The Sizewell C Project

6.14 Environmental Statement Addendum- Non-Technical Summary

January 2021

Plate 2.1: Enhanced permanent beach landing facility when not in use (for the majority of time)

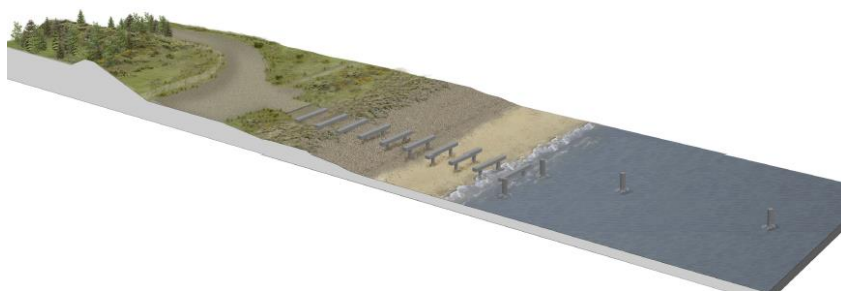
To increase the amount of abnormal indivisible loads that could be delivered by sea during construction, it is necessary to make the seabed in front of the permanent beach landing facility better able to receive more regular deliveries by barge without requiring additional maintenance dredging works. The proposed change would add a grounding platform, which is assumed to be made of a combination of concrete, timber and steel, or similar.

The enhanced permanent beach landing facility and the new temporary beach landing facility are illustrated on **Plate 2.1** and **Plate 2.2**

Plate 2.4: Indicative sketch of flood mitigation area and wet woodland habitat

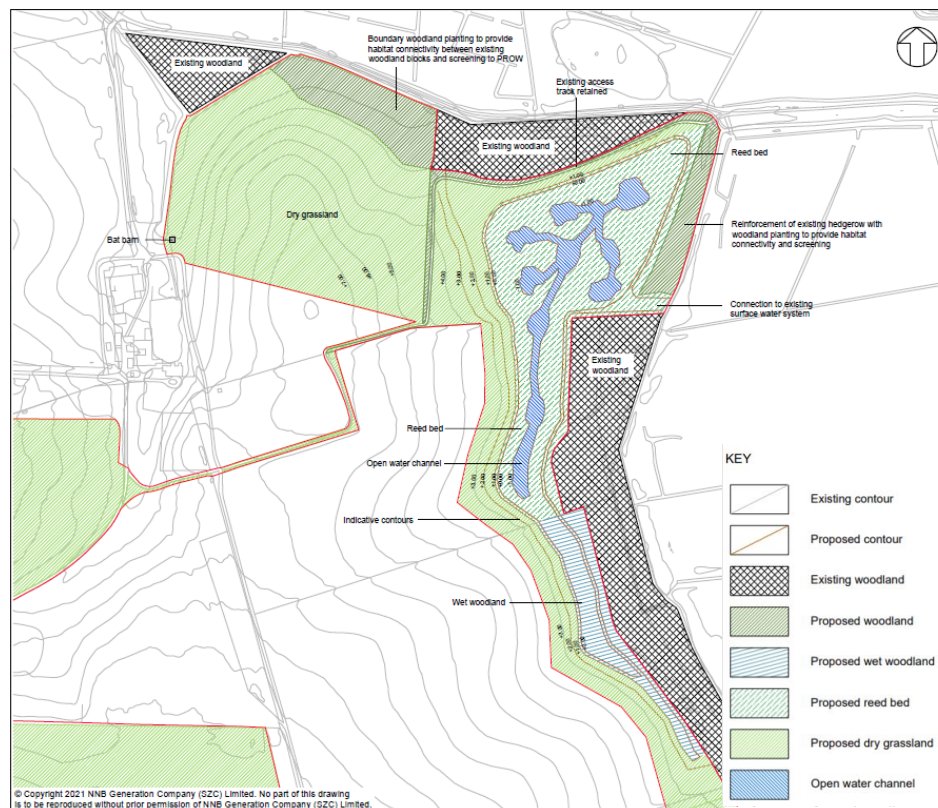
A water resource storage area was proposed in the temporary construction area in the Application to temporarily store non-potable water in the construction phase. SZC Co. is proposing to relocate the water resource storage area within the temporary construction area. This relocation would allow the storage area's original location to instead provide additional, permanent, flood mitigation. Opportunities would also be taken to create additional wetland habitats in this area. The wetland habitats would be open water channels and wet reedbeds to provide high quality foraging habitats for marsh harriers during the construction of Sizewell C.

Once the construction of Sizewell C is complete, the open water and wet reedbed habitats could be transitioned to wet woodland habitats, either through natural successional processes or through planting, as shown on **Plate 2.4**. In the long term, if progressed, this would compensate for the loss of wet woodland from the Sizewell Marshes SSSI.

Plate 2.7: Additional fen meadow habitat at Pakenham

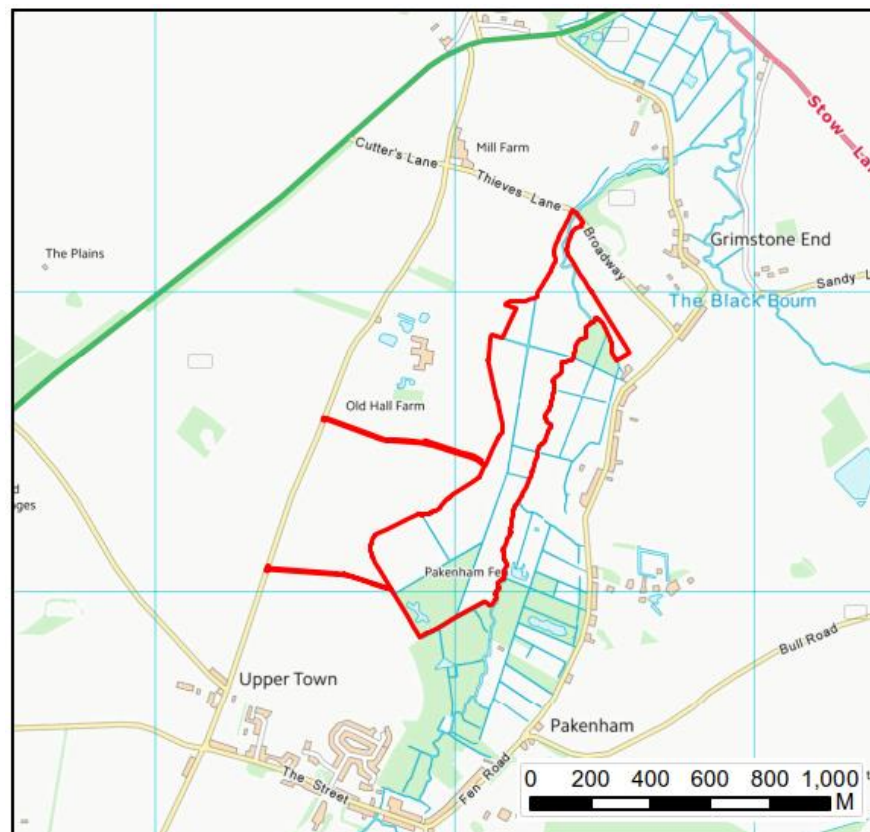
The Application identified two sites for fen meadow habitat at Benhall and Halesworth. Further advice from Natural England as a result of continued engagement, however, recommends that given the rarity of fen meadow in the UK and the known difficulty of restoring species rich fen / fen meadow habitat, that a larger extent of land should be provided in order to ensure sufficient mitigation habitat. SZC Co. is therefore proposing to include a site at Pakenham to further increase the probability of creating sufficient fen meadow habitat to mitigate for the loss of fen meadow from the Sizewell Marshes SSSI (refer to **Plate 2.7**).

A new fen meadow habitat mitigation area has been identified at Pakenham (refer to **Plate 2.7** and **Plate 2.9**). Within the site identified, a total of 4.9ha is considered the primary locus for the creation of new fen meadow habitat, and some of the wider areas on the site may also have the potential for the creation of new fen meadow habitat. The provision of this site would provide further beneficial effects and mitigate for the fen meadow habitat lost in the Sizewell Marshes SSSI. In the event that all of the three offsite areas for fen meadow habitats proposed by SZC Co. (including the sites at Pakenham, Benhall and Halesworth) are successfully established, the Sizewell C Project would provide an overall total of 8.1ha of new fen meadow habitat compared to 0.46ha of habitat lost.

Plate 2.8: Proposed bridleway link between Kenton Hills and Aldhurst Farm

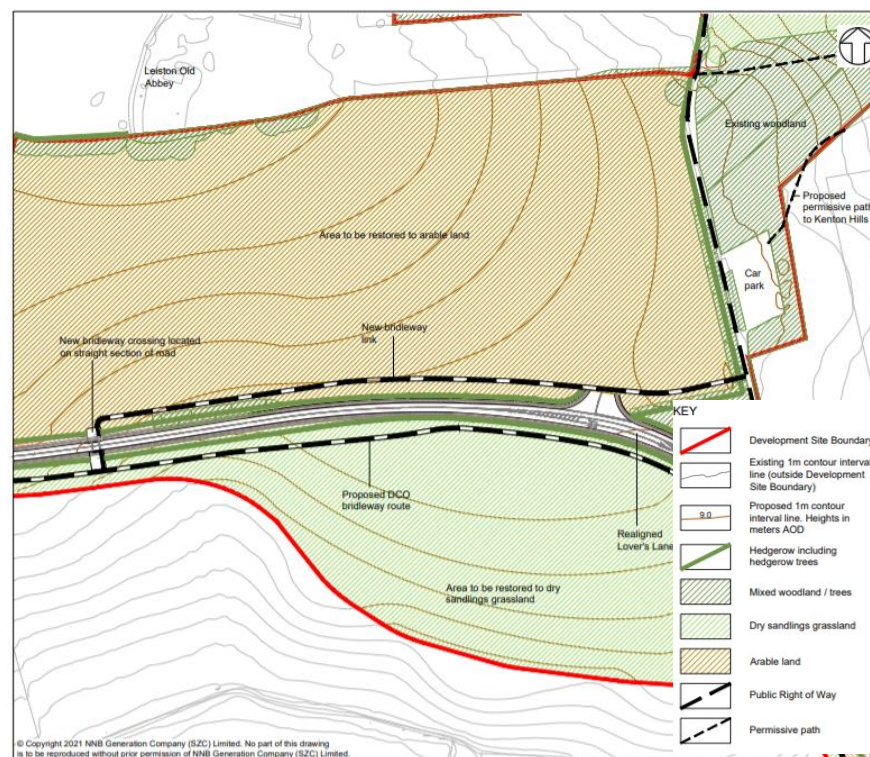
SZC Co. is proposing to deliver a new bridleway link early in the construction phase. It would run from the northern field of Aldhurst Farm towards Kenton Hills to join the existing Bridleway 19 route, including a crossing point over Lover's Lane (refer to **Plate 2.8**). The route would be provided for walkers initially and would be designated as a bridleway once construction of the power station is complete.

Figure 4.1 Illustrative masterplan for the southern park and ride site at Wickham Market

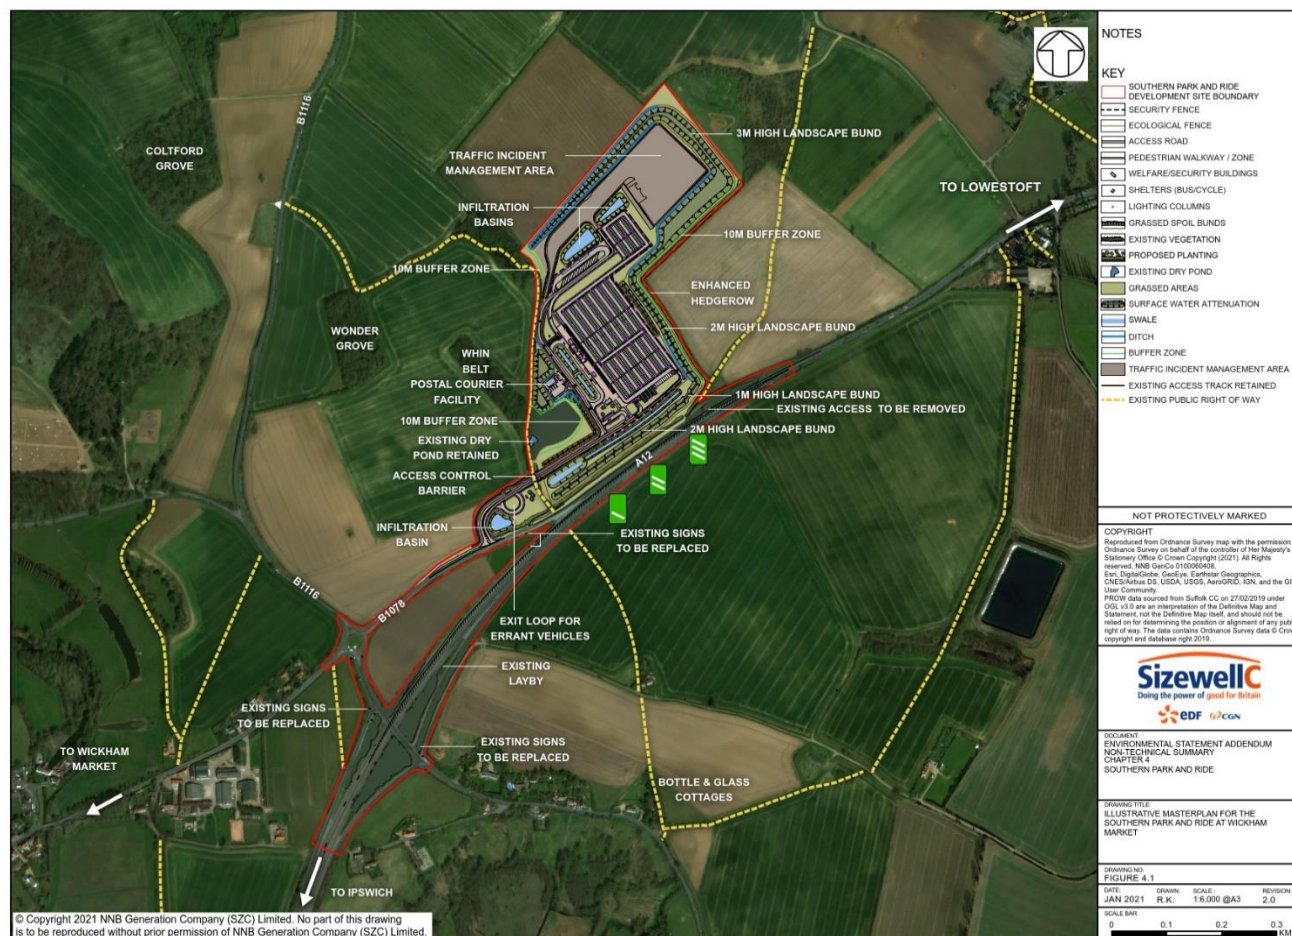
SZC Co. is also proposing to extend the landscape bund adjacent to the north-west boundary and make other minor changes to the site layout and site boundary (**Change 10**). The updated illustrative masterplan is provided in **Figure 4.1**.

Figure 6.1 Changes in the site boundary at the Sizewell link road site

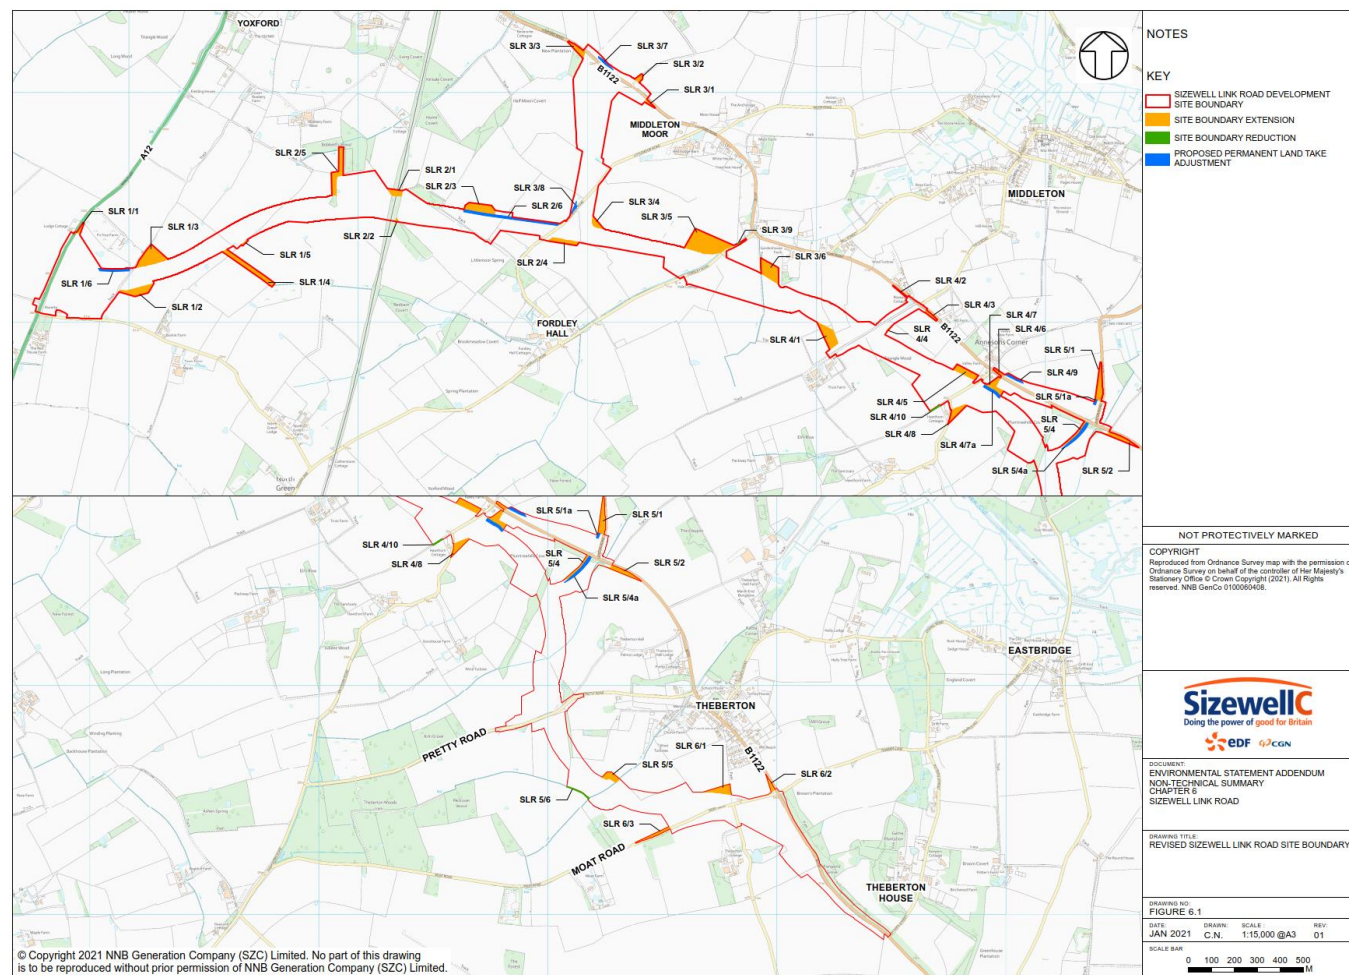
SZC Co. is also proposing a change to the Sizewell link road site which comprises an extension to the site boundary (and thereby an extension of the Order Limits) for additional land as well as minor changes to the public right of way proposals (part of **Change 12**), as shown on **Figure 6.1** (with further detail on reference numbers provided in **Volume 1, Chapter 6** of the **ES Addendum**). These changes are to accommodate updates to drainage design assumptions, highway works and in response to topographic survey information. **Change 12**

also includes a reduction of the site boundary at specific locations where the land has been identified as no longer being required. There are also minor revisions to the Public Rights of Way (PRoW) proposals. **Figure 6.1** illustrates the location and extent of the proposed changes to the site boundary.
